UKGS – Landscaping

ADDENDUM #1

RE: UK Good Samaritan Landscaping – Phase 1

UK CPMD Project No. 2638.0

DETAIL I/C5.0 - CONCRETE RAMP WITH HANDRAILS

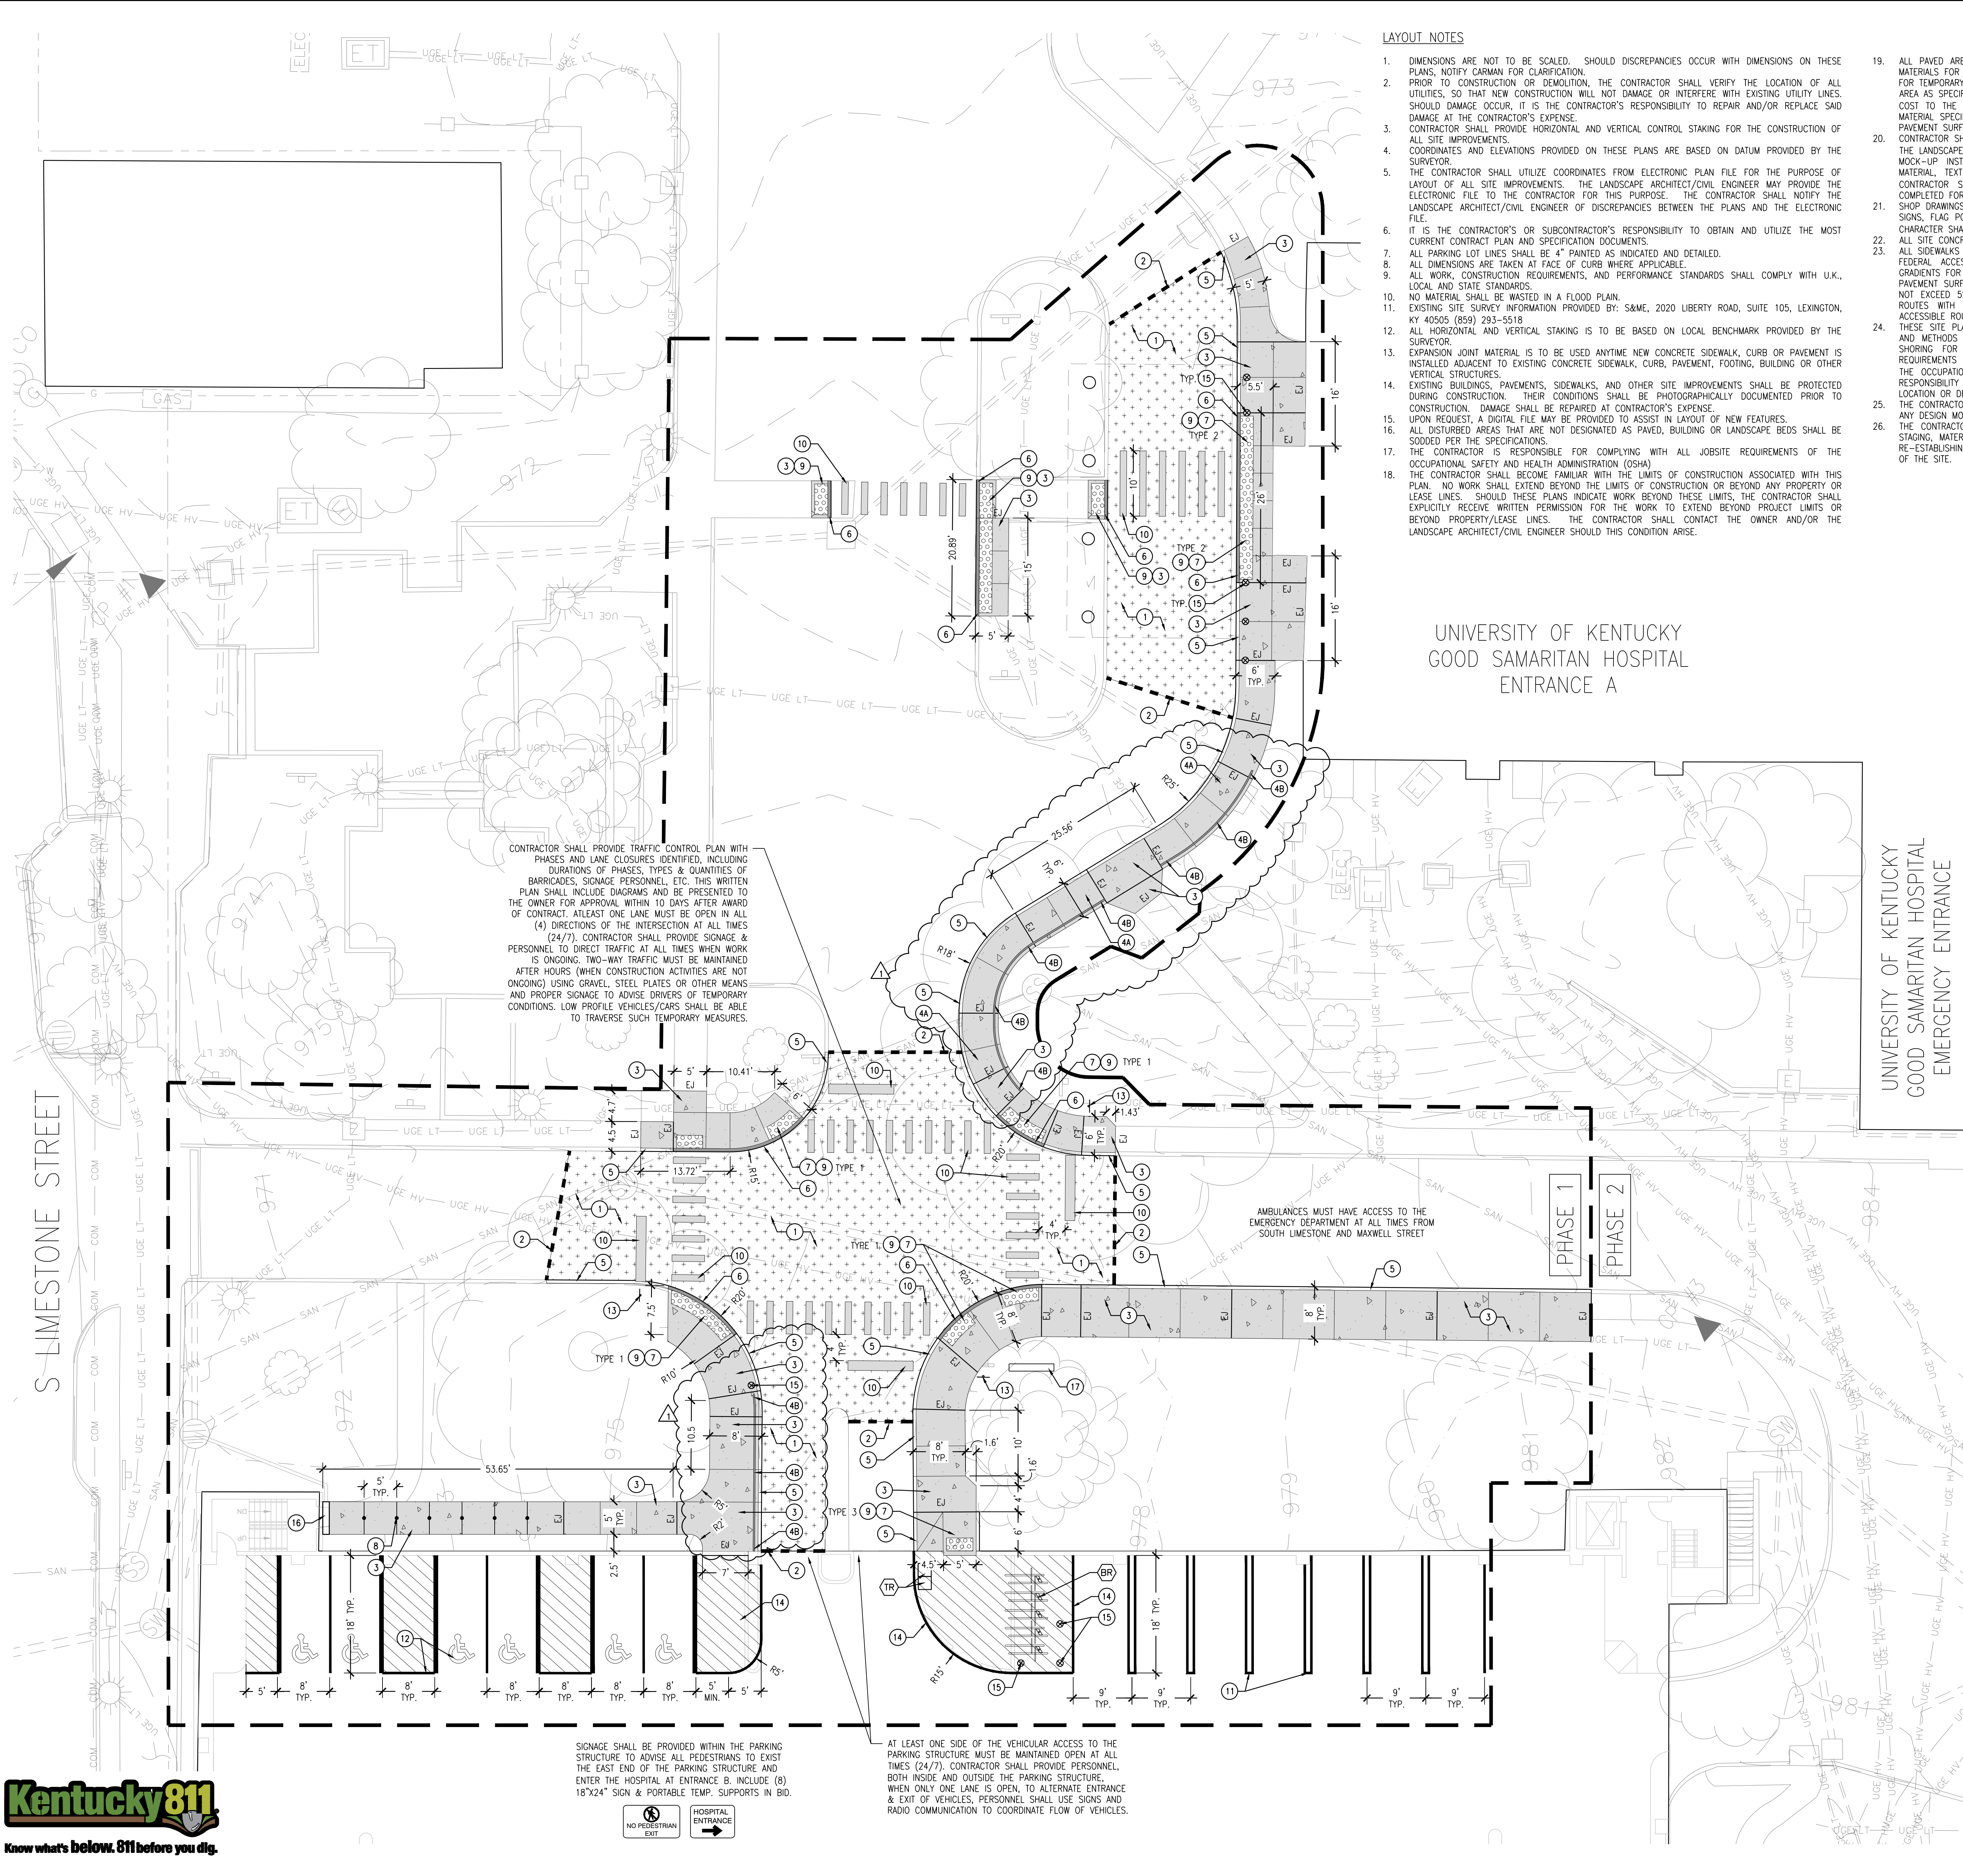
2. Reference drawing sheet C3.0, LAYOUT PLAN ENLARGEMENT. The handrails have been drawn darker on the attached updated drawing sheet C3.0. The locations are not true ramps or designated ADA routes with slopes in excess of 5%, thus handrails are not intended on both sides. Provide only on one side where shown.
3. Reference Coded Note #10 on drawing sheet C1.0, DEMOLITION PLAN. Clarification that Water blasting with hand held wand or without taking the truck into the parking structure is preferred. Alternate methods of paint removal may be used if paint is entirely removed without damaging the concrete surface.
4. Reference detail I on sheet C5.0 and see attached exhibit. Notes regarding handrail materials have been edited to conform with the specifications.

1. Revised drawing sheet C3.0, Layout Plan Enlargement. (Full-size Sheet)
2. Revised detail I / C5.0. (8.5"x11")

1. RAMP LENGTH VARIES SEE PLAN.
2. CONCRETE TO BE 4500 PSI.
3. PROVIDE MEDIUM BROOM FINISH PERPENDICULAR TO DIRECTION ON TRAVEL.
4. FULLY WELD ALL POST/RAILING CONNECTIONS.

LAYOUT PLAN
ENLARGEMENT

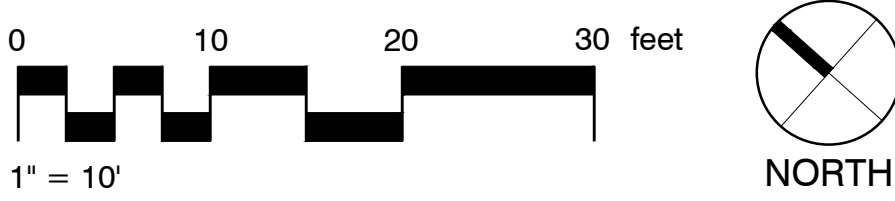
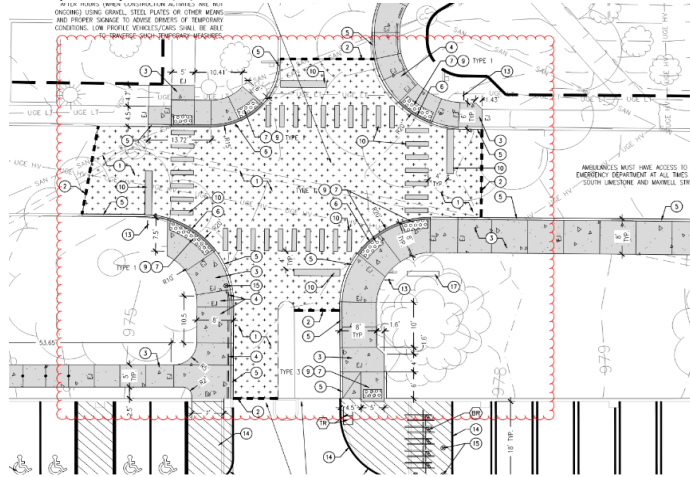
1. Reference drawing sheet C3.0, LAYOUT PLAN ENLARGEMENT where the following note has been added:

IN ORDER TO PROVIDE THE BEST QUALITY SURFACE COURSE OF ASPHALT, THE INTERSECTION MAY BE SHUT DOWN FOR A FOUR-HOUR PERIOD BETWEEN MIDNIGHT FRIDAY AND 4:00AM SATURDAY ON A DATE TO BE IDENTIFIED TO THE OWNER IN WRITING AT LEAST 7 DAYS IN ADVANCE. DURING THIS FOUR-HOUR PERIOD, THE CONTRACTOR MUST PROVIDE TRAFFIC CONTROL PERSONNEL FOR VEHICLES TO ENTER AND EXIT THE PARKING STRUCTURE VIA THE EASTERN ACCESS POINT TO MLK BLVD. THIS ACCESS POINT IS EXTREMELY LOW PROFILE (6'-2") AND CONTRACTOR WILL BE RESPONSIBLE FOR ENSURING THAT NO VEHICLE ATTEMPTS TO ENTER OR EXIT THAT DOESN'T HAVE PROPER CLEARANCE. A CLEARANCE BAR AND WARNING SIGNAGE SHALL BE PROVIDED, IN ADDITION TO FLAG MEN TO COORDINATE ENTERING AND EXITING AND PREVENT DAMAGE TO VEHICLES.

IN ORDER TO PROVIDE THE BEST QUALITY SURFACE COURSE OF ASPHALT, THE INTERSECTION MAY BE SHUT DOWN FOR A FOUR-HOUR PERIOD BETWEEN MIDNIGHT FRIDAY AND 4:00AM SATURDAY ON A DATE TO BE IDENTIFIED TO THE OWNER IN WRITING AT LEAST 7 DAYS IN ADVANCE. DURING THIS FOUR-HOUR PERIOD, THE CONTRACTOR MUST PROVIDE TRAFFIC CONTROL PERSONNEL FOR VEHICLES TO ENTER AND EXIT THE PARKING STRUCTURE VIA THE EASTERN ACCESS POINT TO WALK BLVD. THIS ACCESS POINT IS EXTREMELY LOW PROFILE (6'-2") AND CONTRACTOR WILL BE RESPONSIBLE FOR ENSURING THAT NO VEHICLE ATTEMPTS TO ENTER OR EXIT THAT DOESN'T HAVE PROPER CLEARANCE. A CLEARANCE BAR AND WARNING SIGNAGE SHALL BE PROVIDED. IN ADDITION, FLAG MEN TO COORDINATE ENTERING AND EXITING AND PREVENT DAMAGE TO VEHICLES.
